Road & Bridge Design Publications

Monthly Update – June 2023

Revisions for the month of **June** are listed and displayed below and will be included in projects submitted for the **October** letting. The special detail index from **April** will remain in effect.

6.20.03A

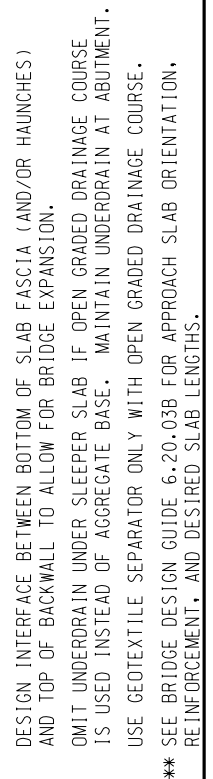
6.20.03A, 6.20.04, 6.23.01, 6.44.01A: Updated notes/details to match polyurethane joint sealant requirements. See Bridge Design Manual Notes 8.07.01 K. & M. Include the Special Provision for Polyurethane Joint Sealant for Structures in projects when using the details/notes. Note that the notes don't match exactly, it is allowed to alter notes to project specific details. See Bridge Design Manual Section 8.01.

*** SEE BRIDGE DESIGN GUIDE 6.20.03B FOR APPROACH SLAB ORIENTATION, REINFORCEMENT, AND DESIRED SLAB LENGTHS.

6.60.11

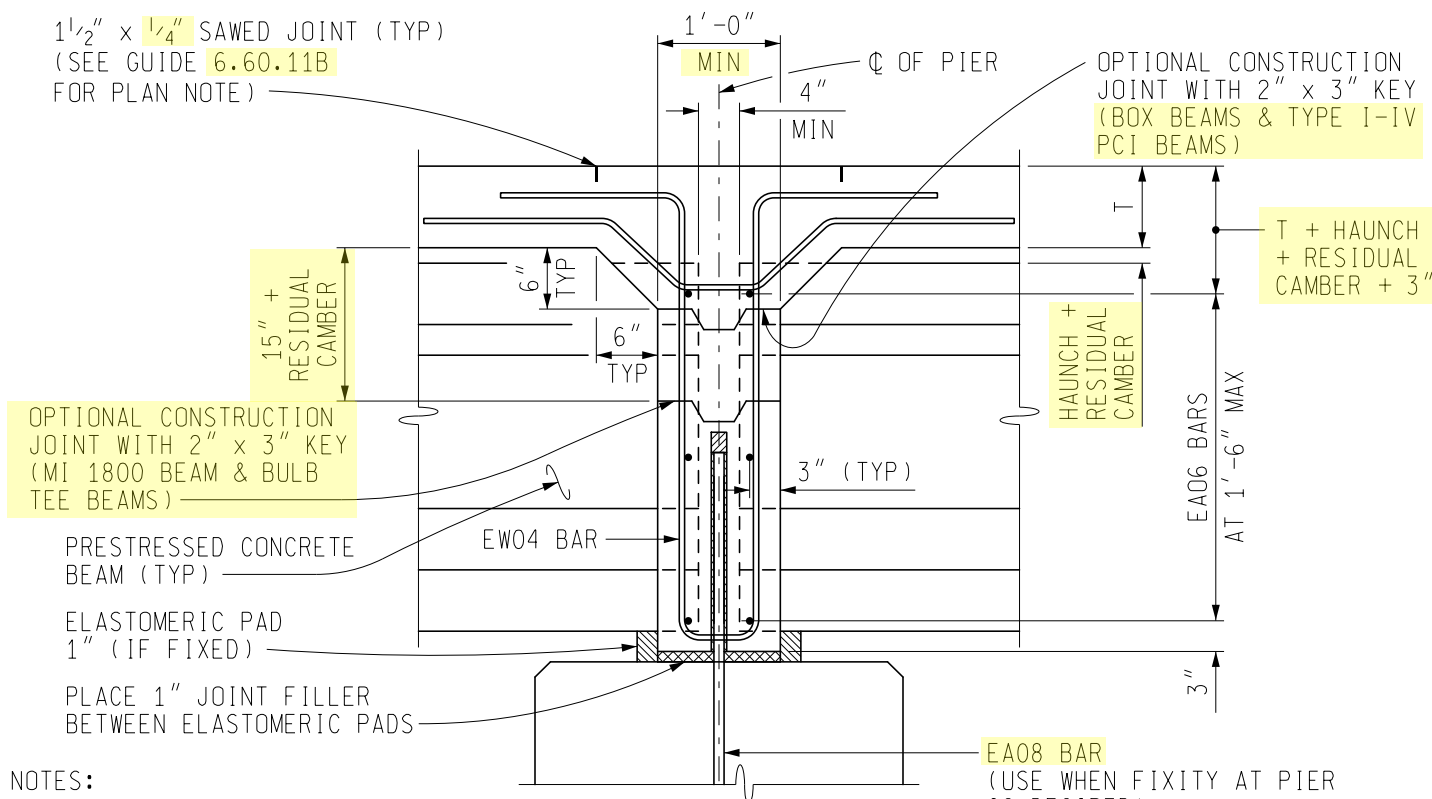
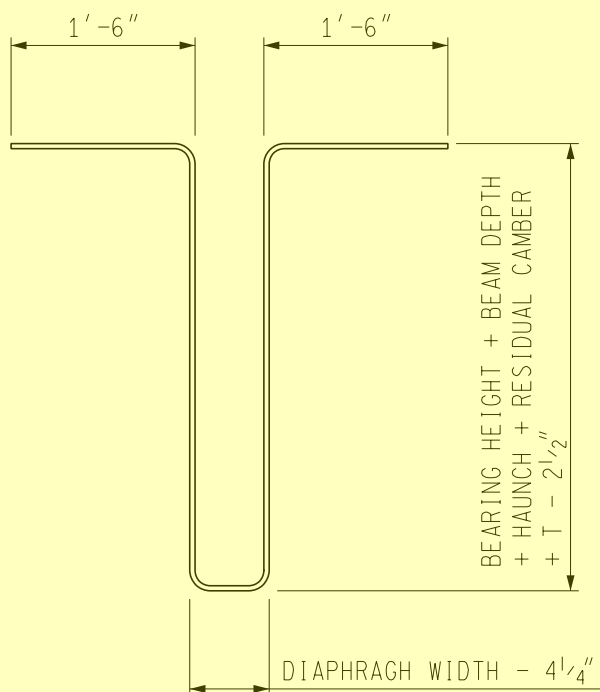
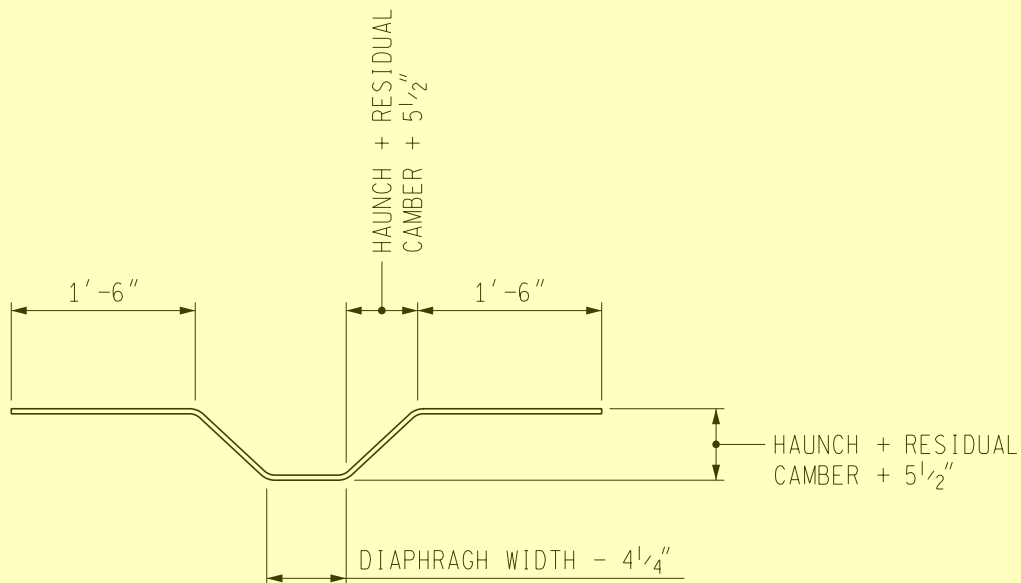
6.60.11, .11A & .11B.: Polyurethane note is updated, see above. EA08 bars are updated to match a previous requirement for epoxy coating. More detail is given to EW bars to get proper embedment and development into the deck slab. A secondary optional construction joint is added for MI 1800 beams and Bulb Tee beams. The joint is lowered to minimize the risk of cracks developing in the wide top flanges when the diaphragm is cast prior to the bridge deck. The optional joint for Box Beams and PCI beams will remain at the bottom of the 6" bevels.

1½" x ¼" SAWED JOINT (TYP)
(SEE GUIDE 6.60.11B
FOR PLAN NOTE)

6.60.11B

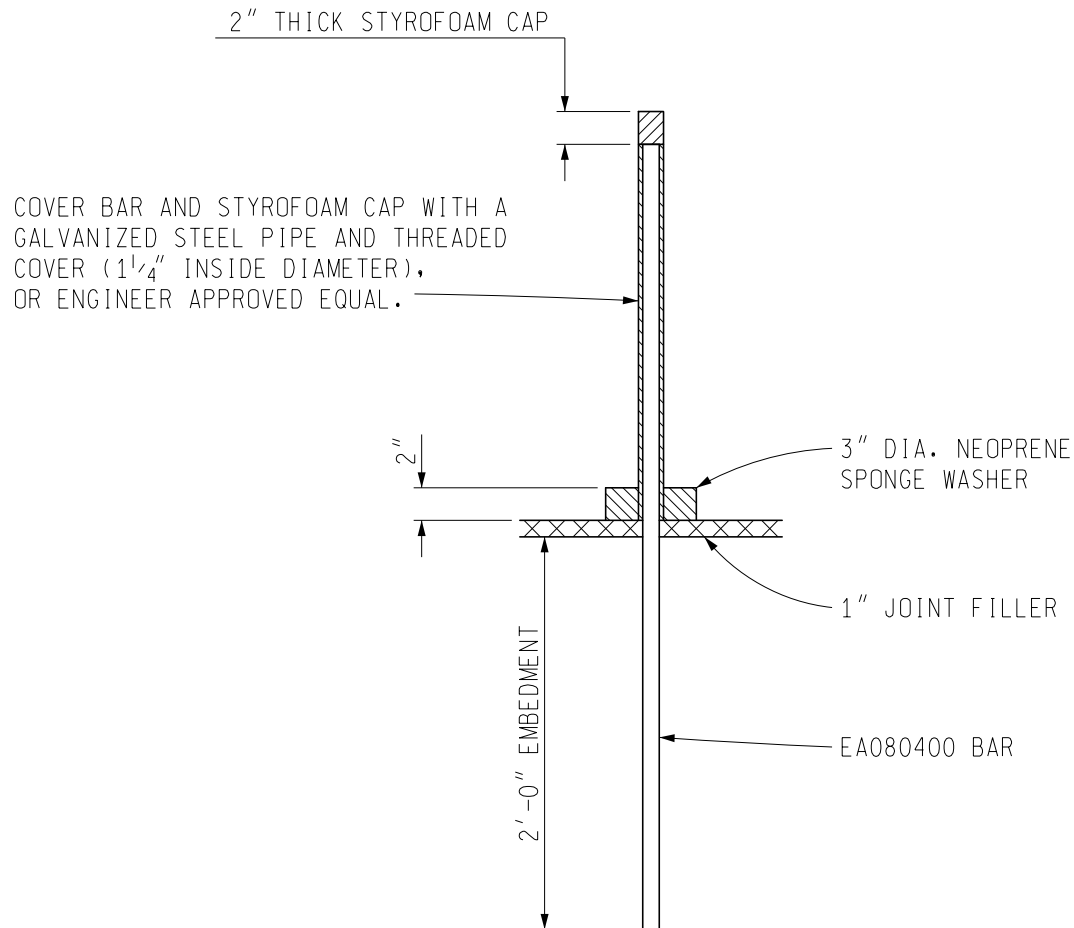
Table of Contents: Added guide 6.60.11B related to Pier Diaphragm....Continuous for Live Load. More details were added and facilitated another guide.

PROVIDE A SAWED JOINT 1 1/2" DEEP BY 1/4" WIDE (MINIMUM) IN THE TOP OF SLAB AT THE LOCATIONS SHOWN IN SECTION(S) _____. SAW THE JOINT WITHIN 24 HOURS OF PLACING THE CURING AND FILL TO 1/2" BELOW TOP OF CONCRETE WITH POLYURETHANE OR POLYURETHANE HYBRID SEALANT. (INCLUDED IN THE BID ITEM "SUPERSTRUCTURE CONC. FORM, FINISH, AND CURE, NIGHT CASTING (STRUCTURE NO.)").
